Our Ref: 35437-006-01
Your Ref: MCUI 2026_5936/1

**Information Request Response – Development Application MCUI 2026_5936/1
Material Change of Use for Solar Farm (including ancillary device for storing and
releasing energy)
6868 Captain Cook Highway, Killaloe – Lot 32 on SP332240**

Visual Assessment Report

Proposed Solar Farm

DRAWN	RG
APPROVED	RG
SCALE	N/A @ A3
DATE	APRIL 2026
SHEET No.	LPS_1
JOB No.	L2415

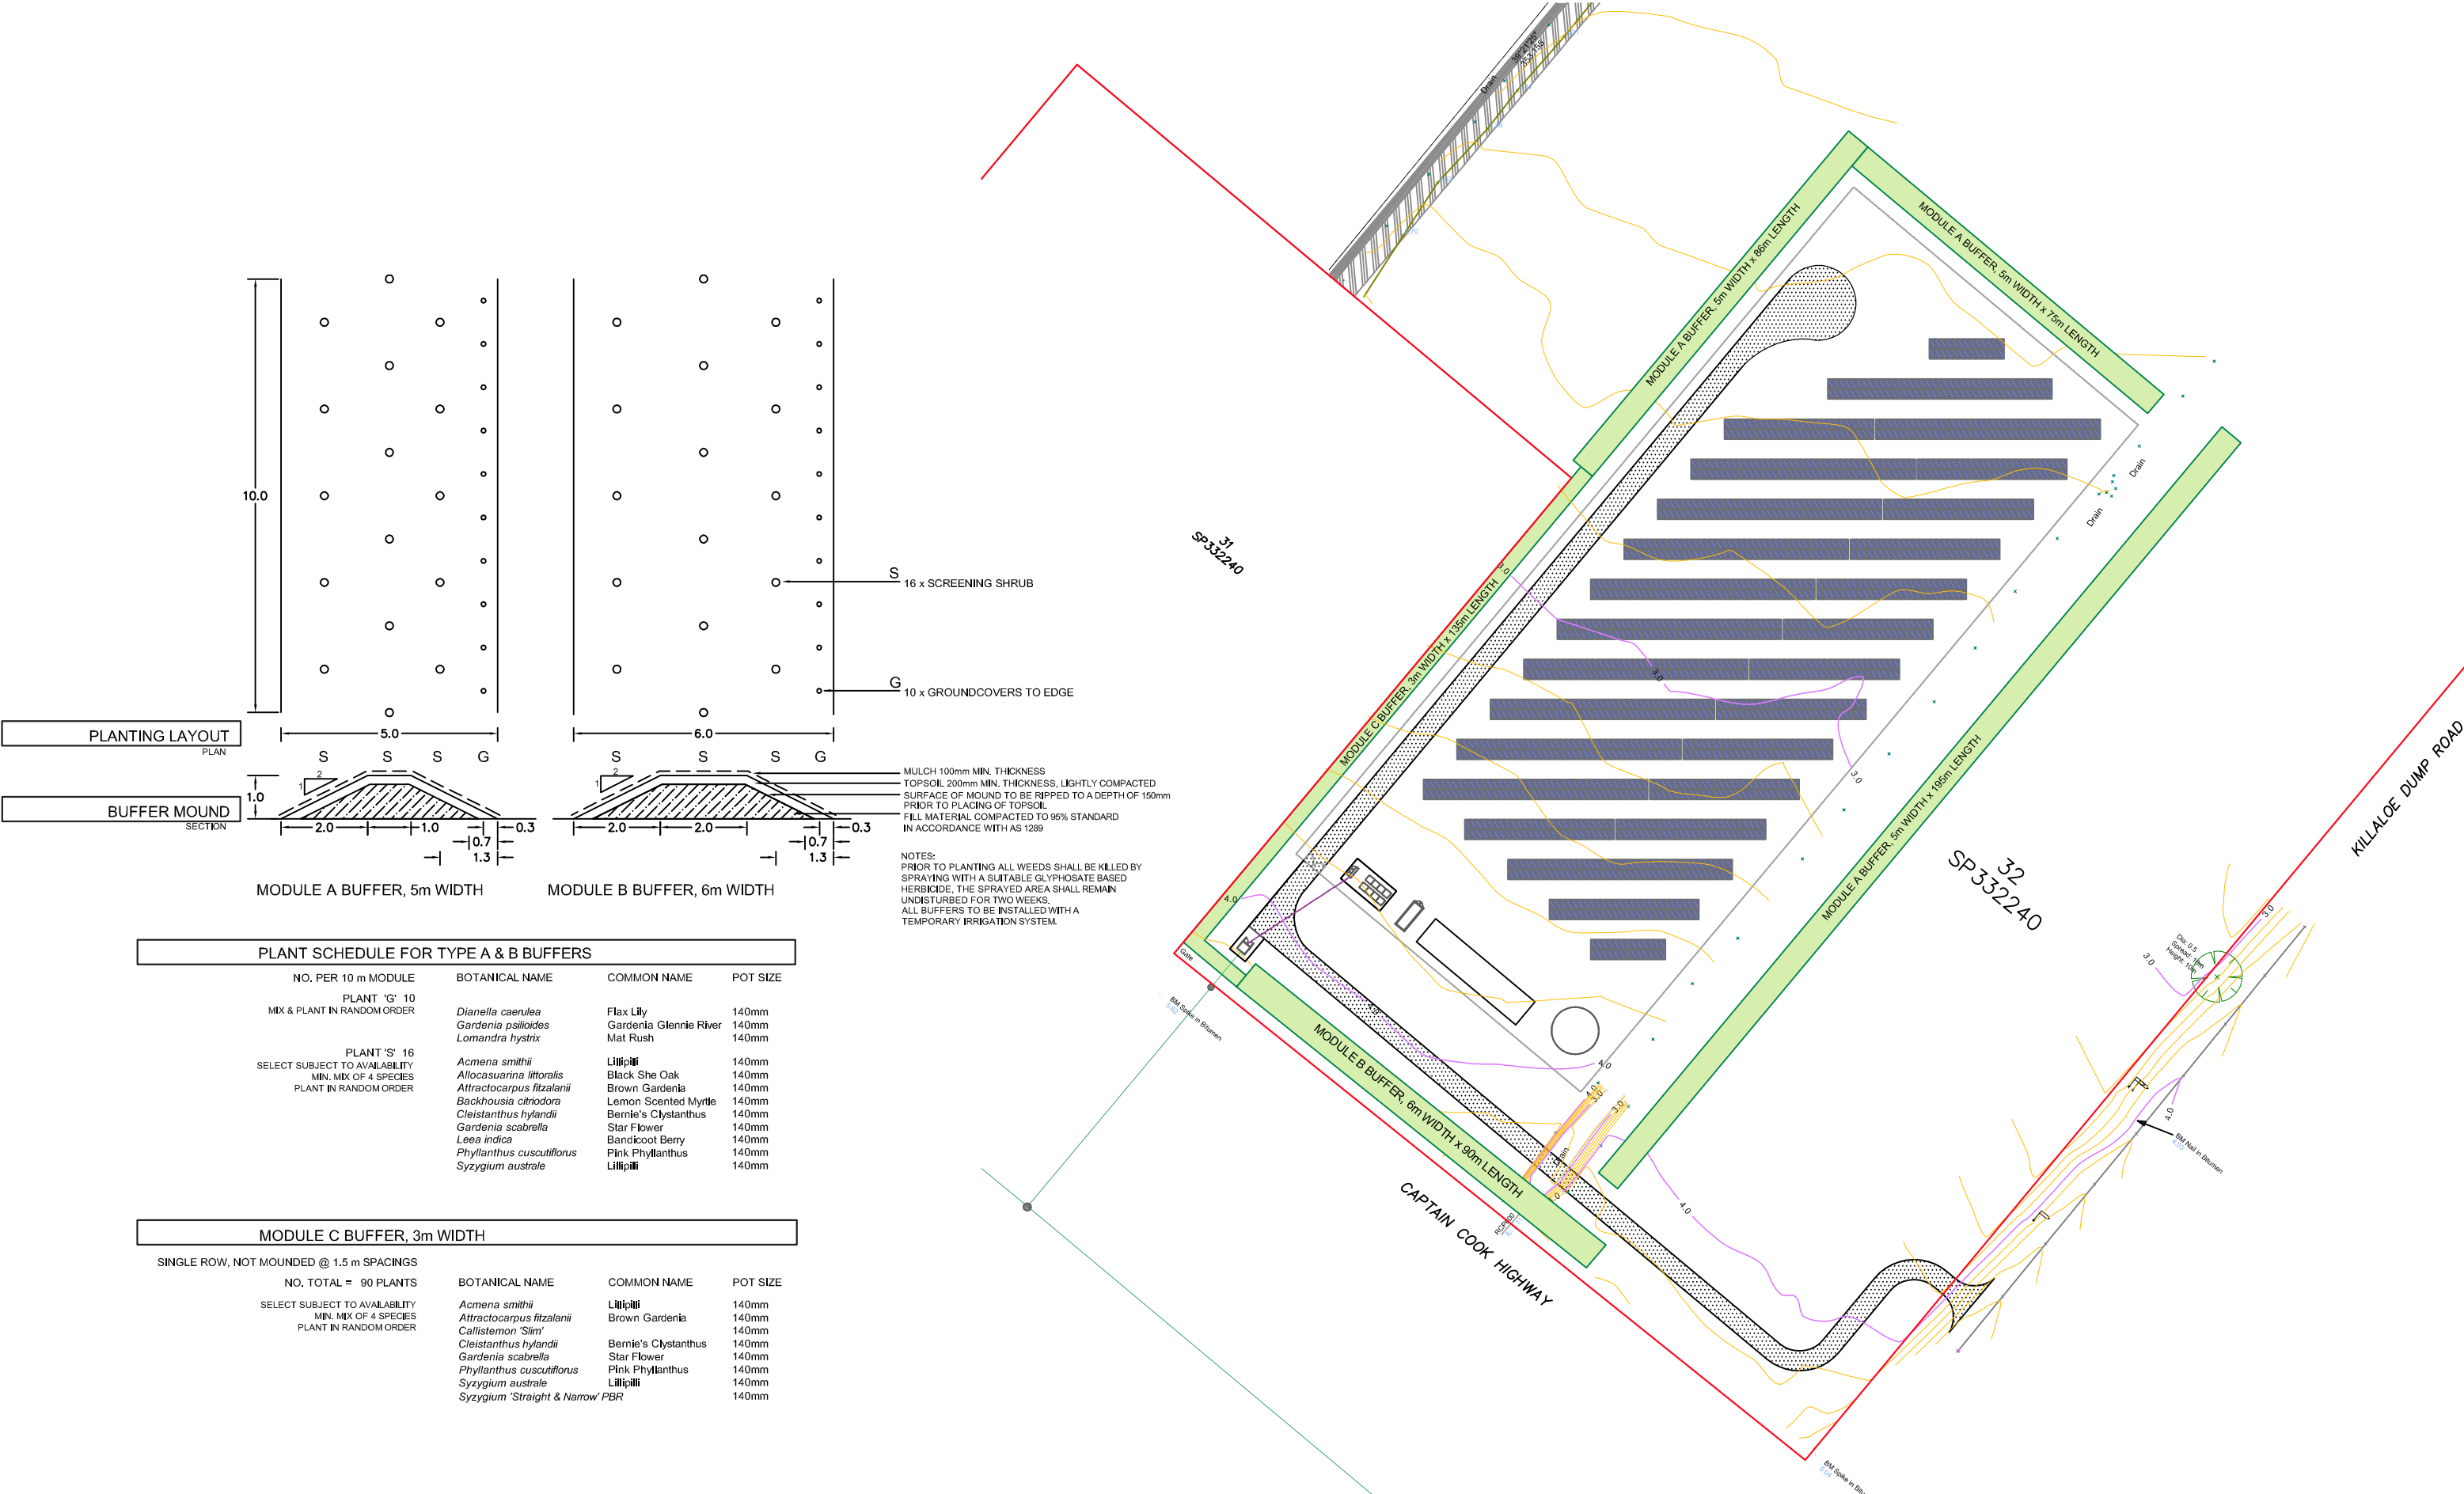
- 2. *The applicant is requested to provide a Detailed Landscaping Plan in accordance with the Landscaping Code and Planning Scheme Policy SC6.7 prepared by a suitably qualified and experienced Landscape Architect or Landscape Designer, demonstrating:*
 - a. *A typical planting plan and plant schedule which is generally in accordance with that shown on the concept landscape plan referenced; Proposed Solar Farm Vegetated Buffer Layout Plan, Job No. L2415, Sheet No. LPS_2, prepared by GGI Landscape Architects;*

- b. *A typical planting plan including the location, number and minimum size at time of planting; dimensions of planting beds and details of any bunds/batters, visual barrier fences associated with the landscape design;*

- c. *A planting schedule including endemic or native species suitable to the area, quantities and densities, planting sizes, dimensions of planting areas and canopy heights and spread at years 0, 3 and 5 from the time of planting;*

Please refer to a copy of the revised landscaping plans included at sheets LPS_1, LPS_3 & LPS_4 Rev A and of the amended Visual Impact Assessment prepared by GGI Landscape Architects included within **Attachment A**. The plans provide a Detailed Landscaping Plan in accordance with the Landscaping Code and Planning Scheme Policy SC6.7

Sections of buffering through highway

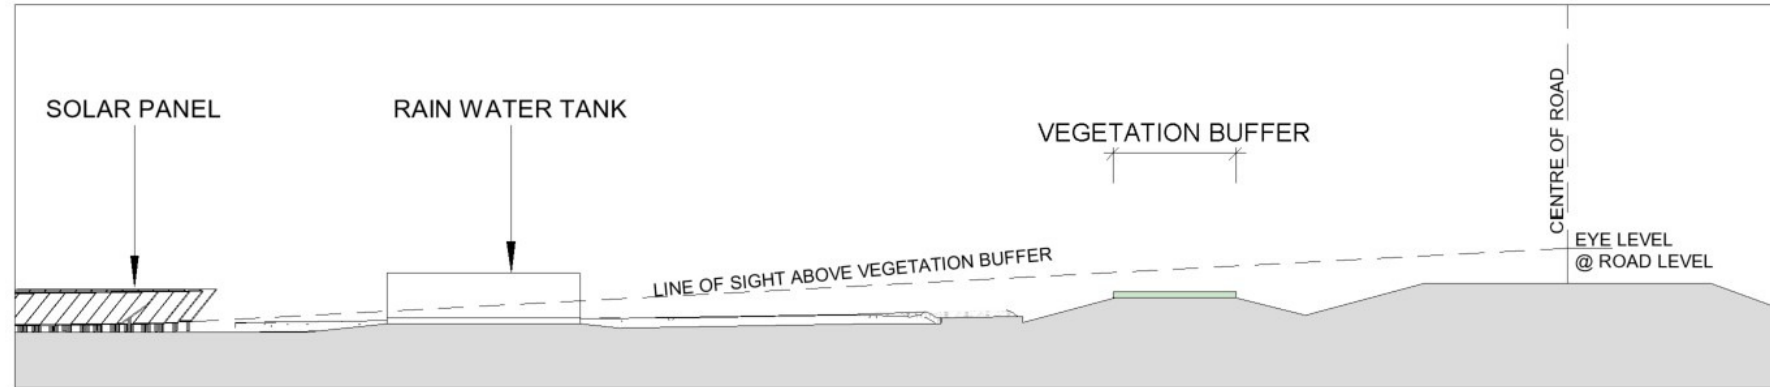
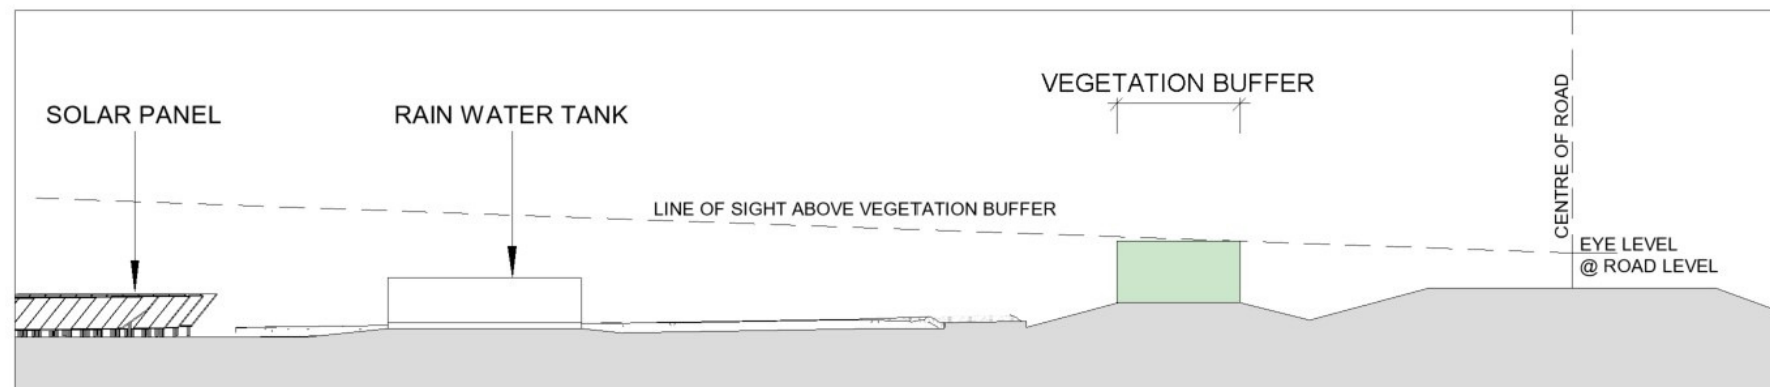
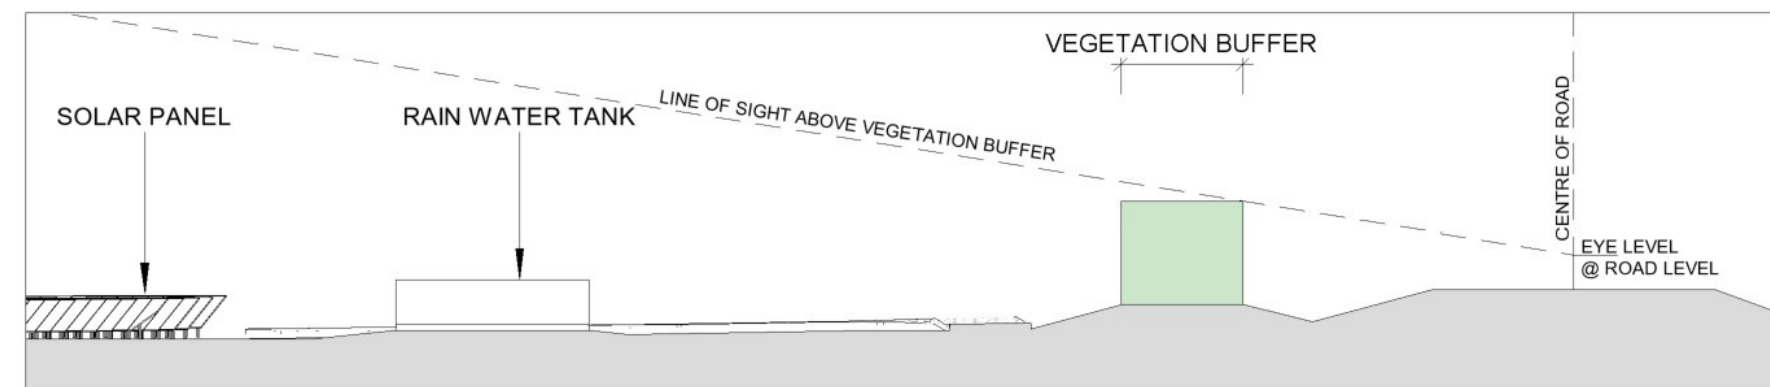
Council Officers acknowledge that the application proposes a mounded vegetation buffer which is intended to screen the proposed solar farm from all directions and projected to reach maturity within 3 years however the application material does not include any information detailing the height of the proposed mound/ bund.

Officers are seeking further information to verify that the proposed vegetation buffer will suitably screen the solar farm from significant viewpoints, including any nearby high sections of the Captain Cook Highway.

A landscape buffering design was developed to entirely screen the development when the landscaping reaches full maturity, in particular from view points 1 and 2. The viewing points and the rendered images in Section E Photomontage views demonstrate that the proposed solar farm development will be heavily screened by the proposed deep vegetation buffer proposed along the Cook Highway frontage, parallel to the Killaloe Dump Road, and along its northern boundary beside Vic's Nursery. Views into the solar farm should be screened out around 3 years from completion, with proposed layered and staggered planting on one metre high mounded earth. The proposed vegetation buffer itself creates a low profile that will not detract from the natural lay of the land or impact views of the distant mountains.

The landscape buffer design, at full establishment, will reach a maximum height around 7m above the natural ground, including the 1m high earth mound, with the most dense foliage from ground level to approximately 4m high. (Refer proposed buffer plant species schedule)
